SUMMARY OF REVISIONS

SOUTH WATERFRONT  
4310 SW MACADAM

On the 4th of November, 4310 SW Macadam was reviewed by the City of Portland Design Commission. The modifications developed between the first Design Review hearing on October 7th and second Design Review hearing on November 4th were described as good improvements and the Commission remarked that the design team had done a good job of listening to the concerns expressed earlier and responding positively to them. The Commission indicated that with minor modifications to the presented design, 4310 SW Macadam could be approved at the following hearing scheduled for November 18th.

ENLARGED GROUND FLOOR PLAN - INITIAL DEVELOPMENT

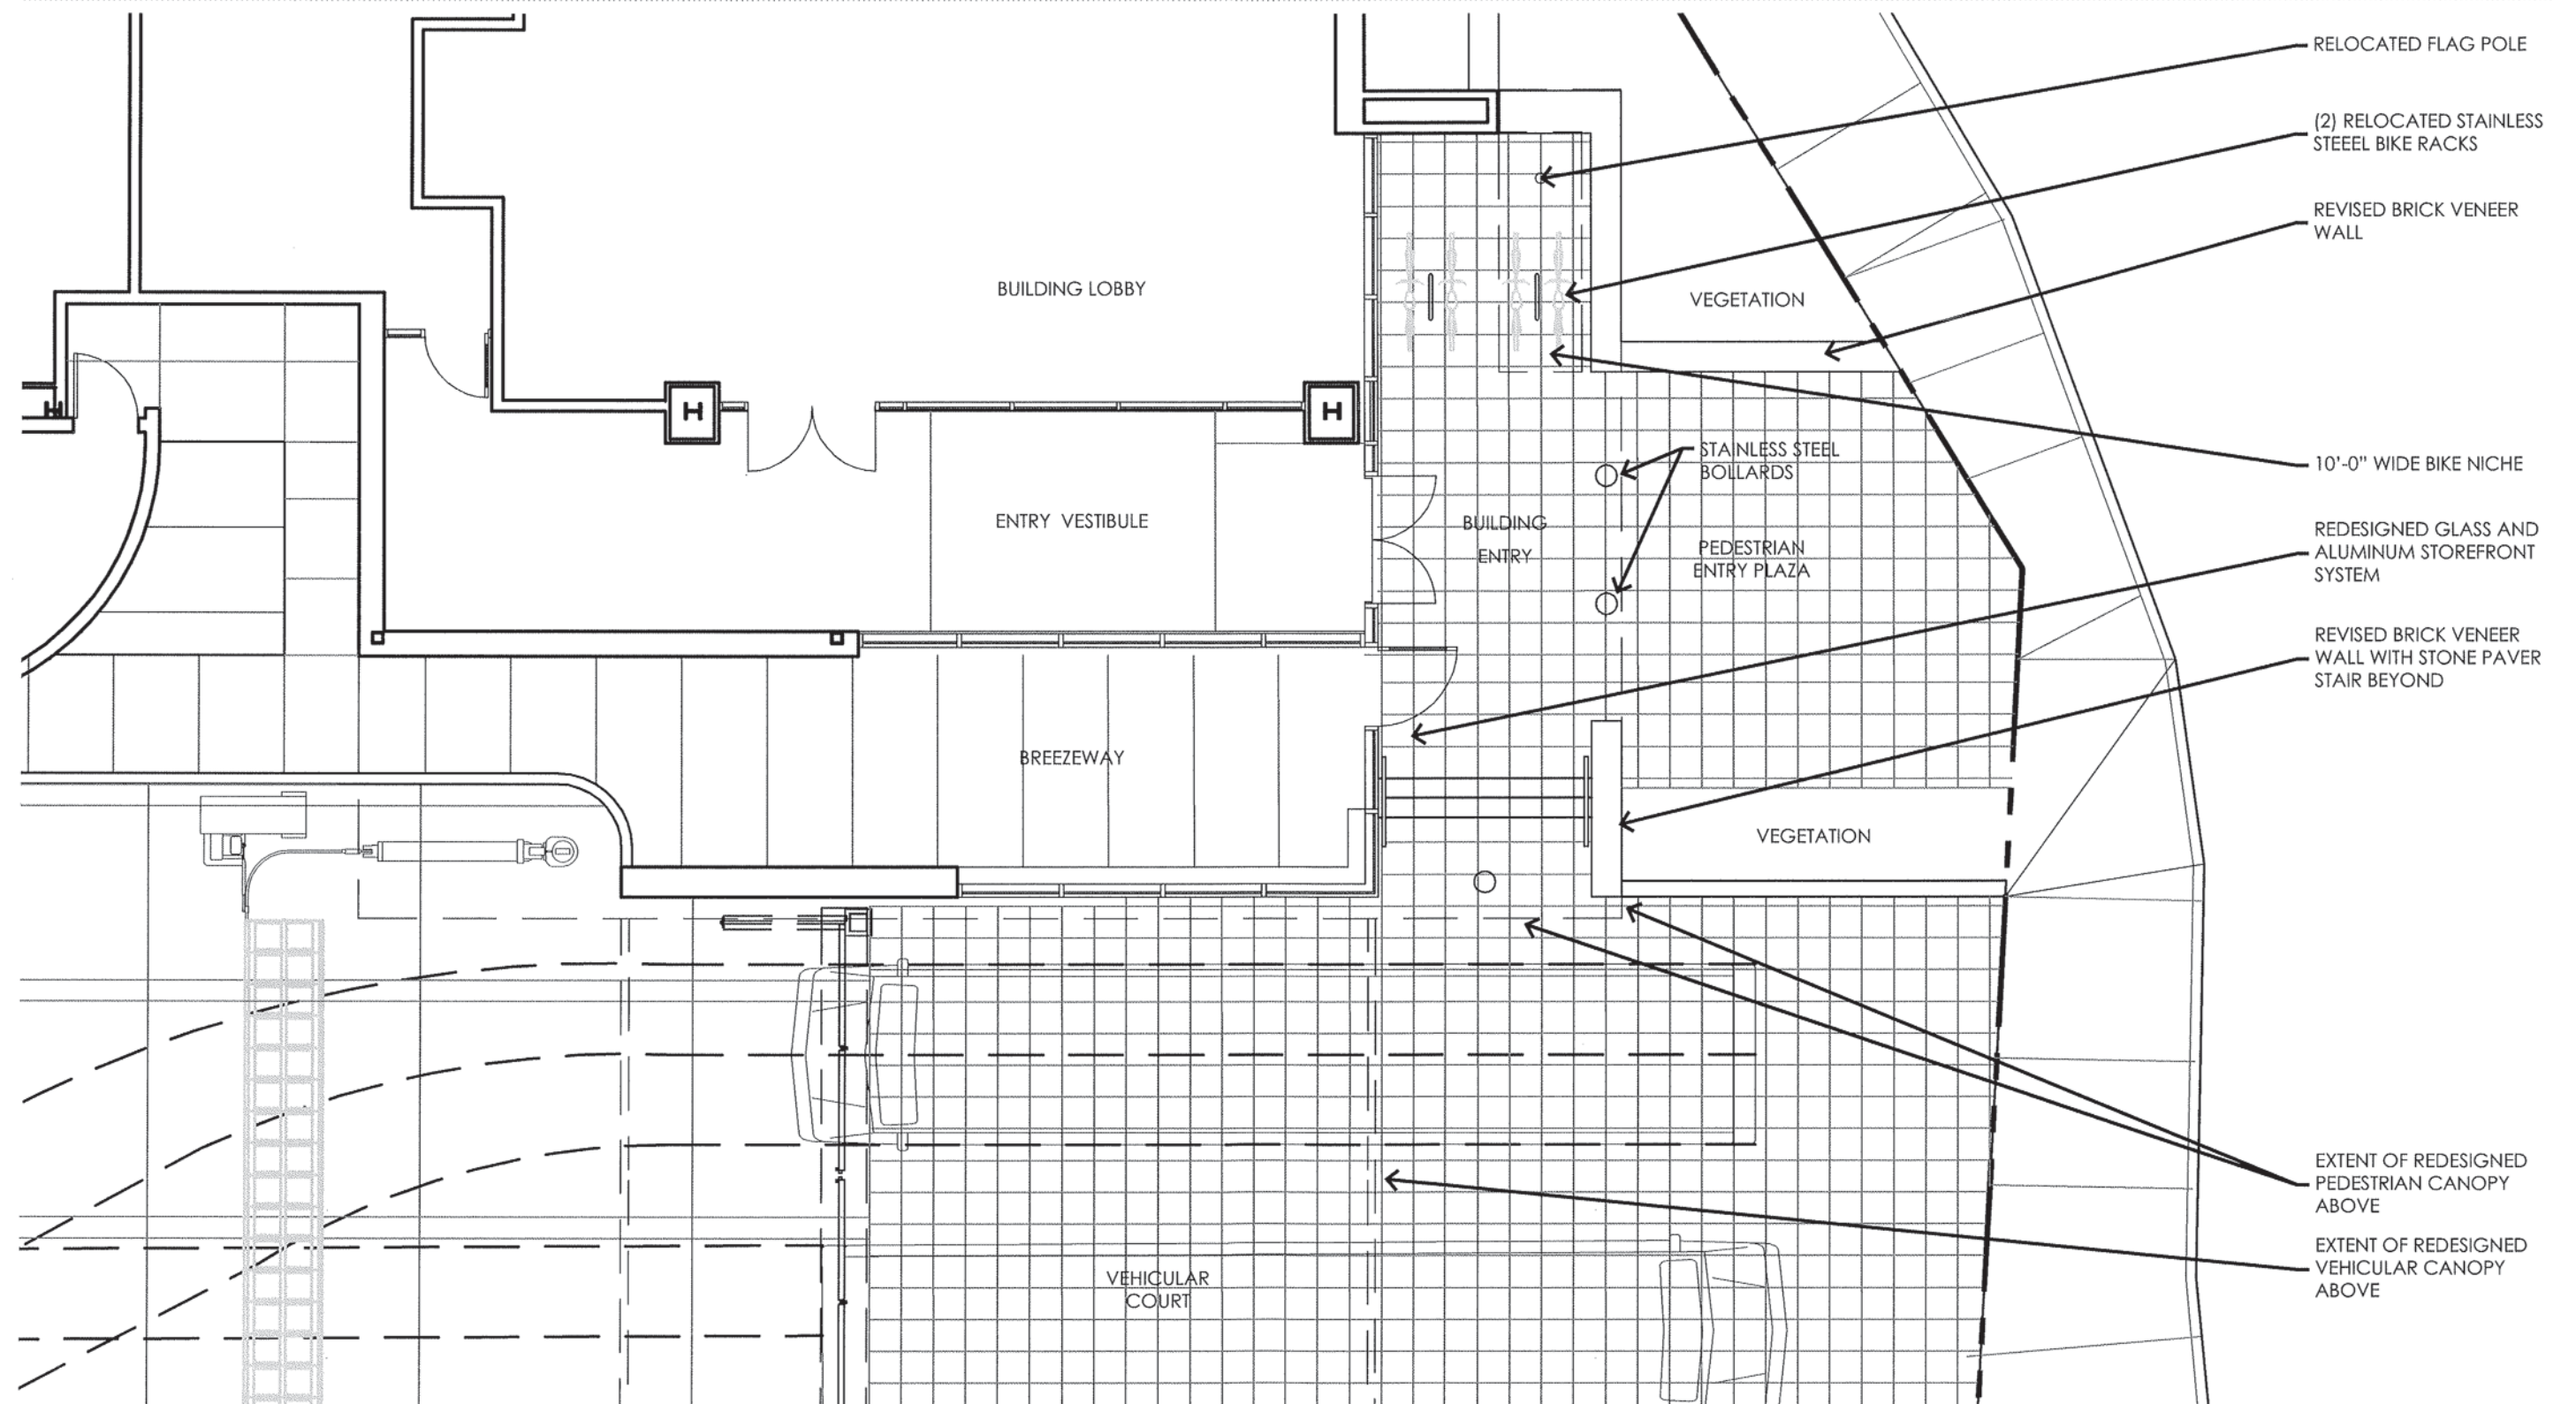
- 1. The design of the gatehouse
- 2. The design of the vehicle entry canopy
- 3. The design and profile of the pedestrian entry canopy
- 4. Widening of the bike niche at the pedestrian entry
- 5. Clarification of the color of glass at the glazed overhead door, the glazed breezeway, and the pedestrian entry

- Revision 1 - The exterior of the gatehouse is revised to better match the proportions and materiality of the proposed addition.
- Revision 2 - The structural steel members of the vehicle entry canopy have been reduced in height from 24" to 18".

- Revision 3 - The pedestrian entry canopy was redesigned to aesthetically resemble the roof overhang developed on the southwest corner of the addition along SW Macadam. The perimeter was reduced in height from 3'-0" to 2'-0". Additionally, the entry glazing has been further developed.

- Revision 4 - The niche adjacent to the main building entry has been widened to a clear width of 10'-0" and the flag pole relocated to accomodate two bicycle racks.

- Clarification - The glazing at the overhead door is a consistent translucent white glass. The vision glazing and the spandrel glazing at the breezeway and at the pedestrian entry is the same glass as exists throughout the building addition and does not vary in color.
